Wisconsin Department of Transportation

Proposal #18: 2703-08-71, WISC 2026225
C Racine, S Memorial Dr
Durand Ave to 17th St
Local Street
Racine

This is Addendum No. 01, which provides for the following:

ADDENDUM NO. 01

Addendum No. 01
 ID 2703-08-71
 Revised Sheet 12
 March 4, 2026

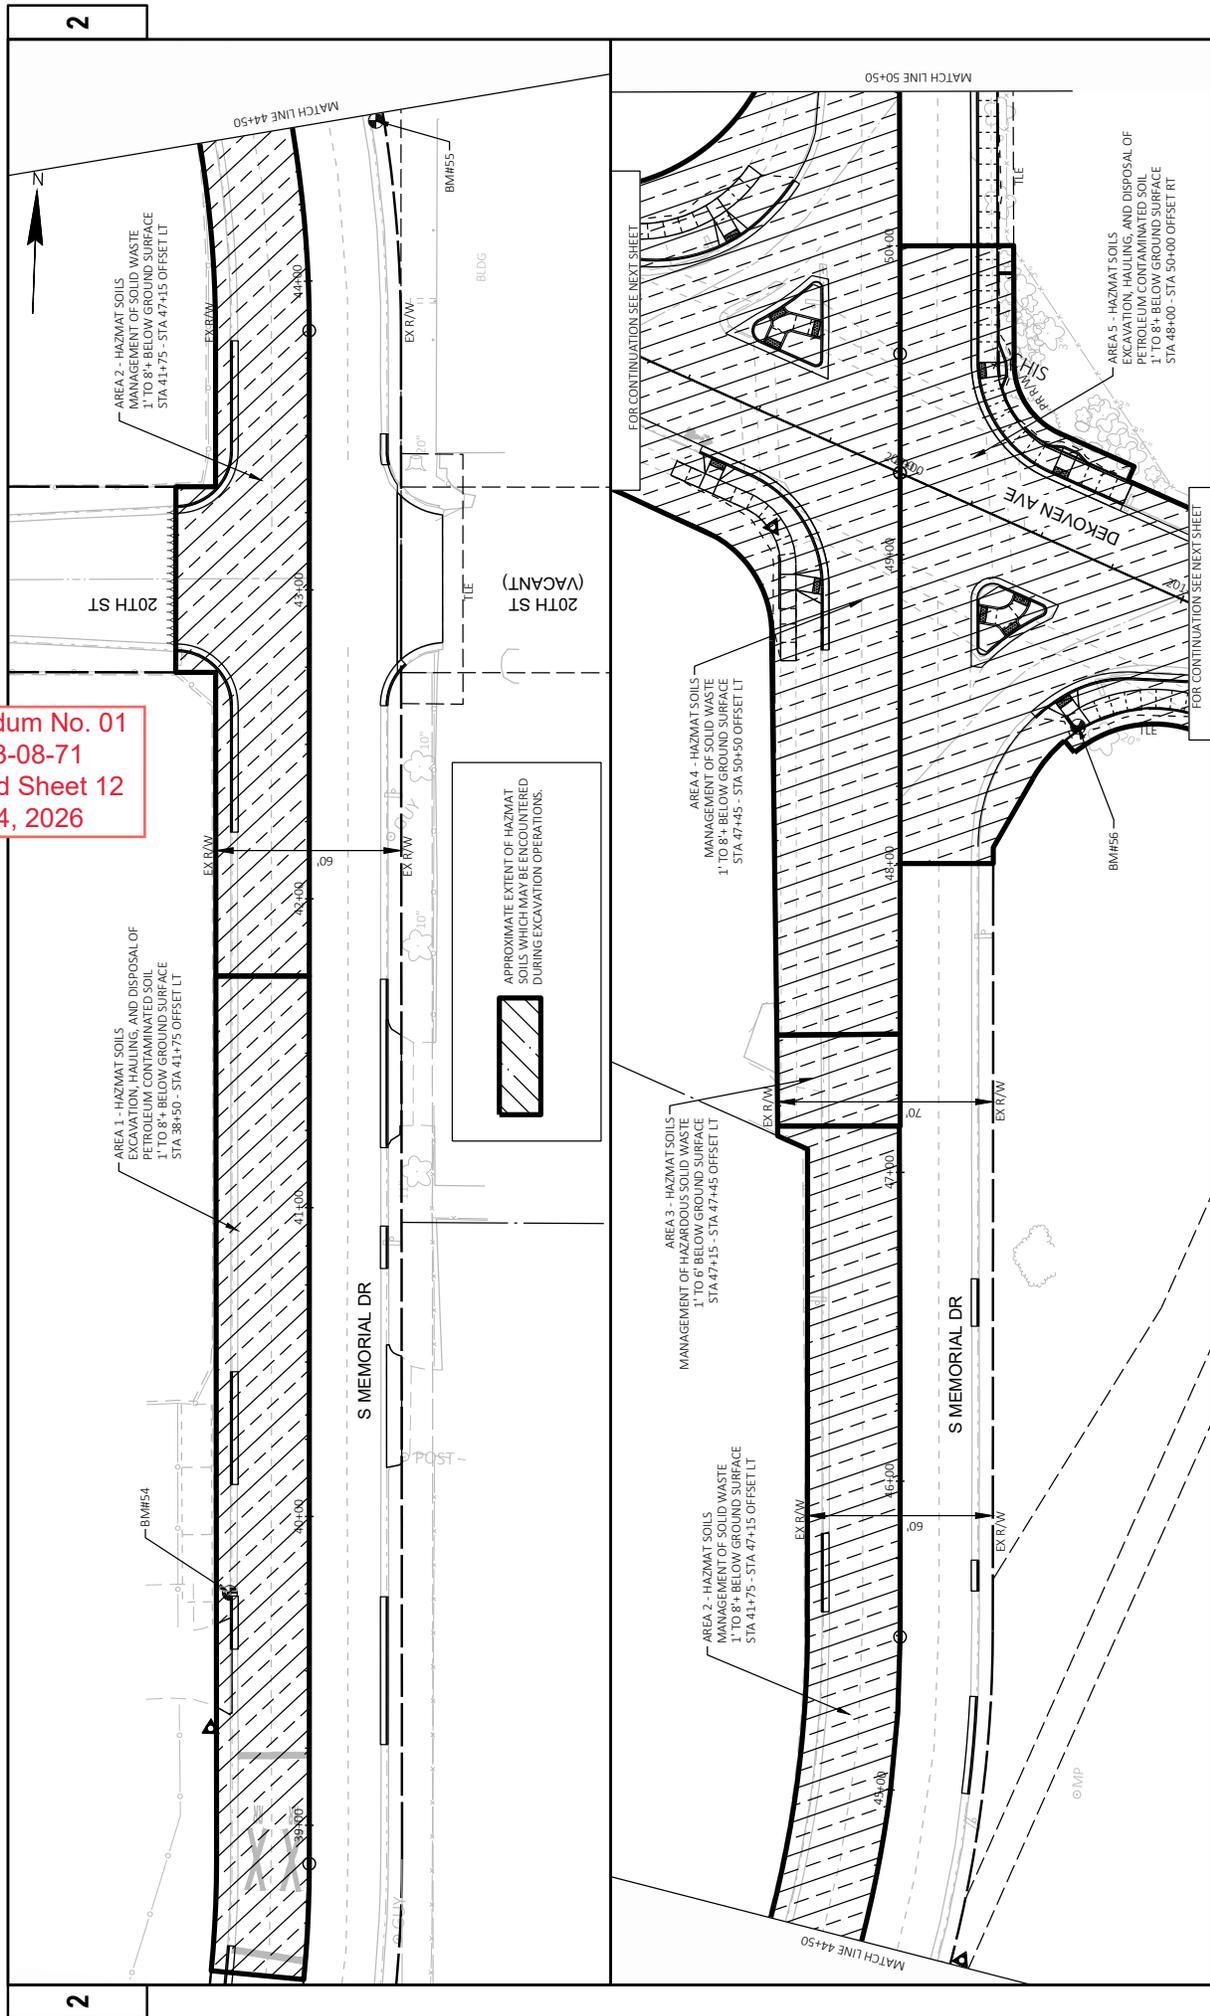
Revised Plan Sheets	
Plan Sheet	Plan Sheet Title (brief description of changes to sheet)
12	Hazmat Soils (Added new hazmat areas and updated the callouts for existing areas)
13	Hazmat Soils (Update the callouts for existing hazmat areas)
94	Miscellaneous Quantities (Updated Solid Waste Management table)

AREA 6 - HAZMAT SOILS
EXCAVATION, HAULING, AND DISPOSAL OF
PETROLEUM CONTAMINATED SOIL
1' TO 6' BELOW GROUND SURFACE
STA 54+00 - STA 55+00 OFFSET LT

AREA 4 - HAZMAT SOILS
MANAGEMENT OF SOLID WASTE
1' TO 8" BELOW GROUND SURFACE
STA 47+45 - STA 50+50 OFFSET LT

Addendum No. 01
 ID 2703-08-71
 Revised Sheet 13
 March 4, 2026

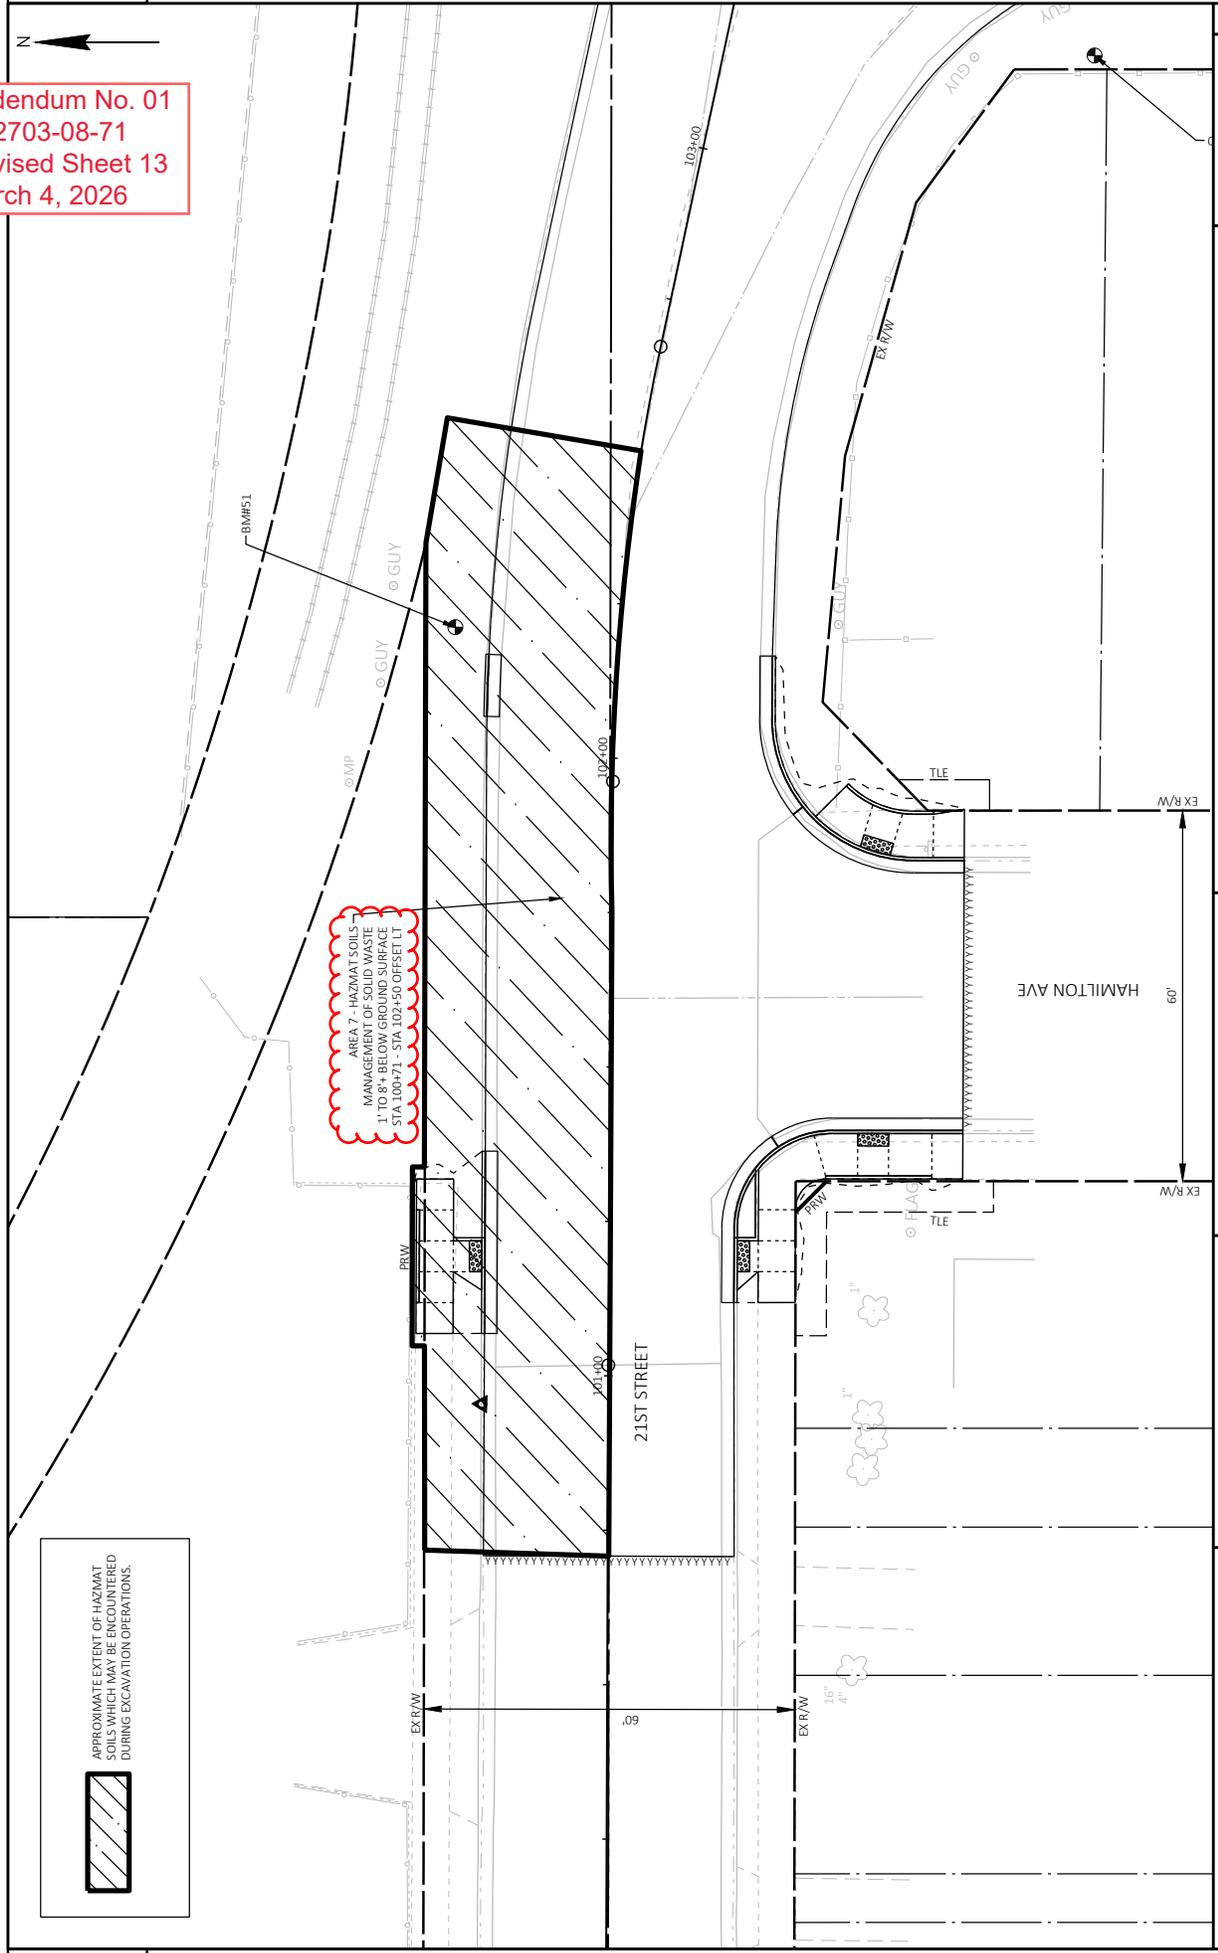
AREA 7 - HAZMAT SOILS -
 MANAGEMENT OF SOLID WASTE
 1' TO 8' BELOW GROUND SURFACE
 STA 100+71 - STA 102+50 OFFSET LT
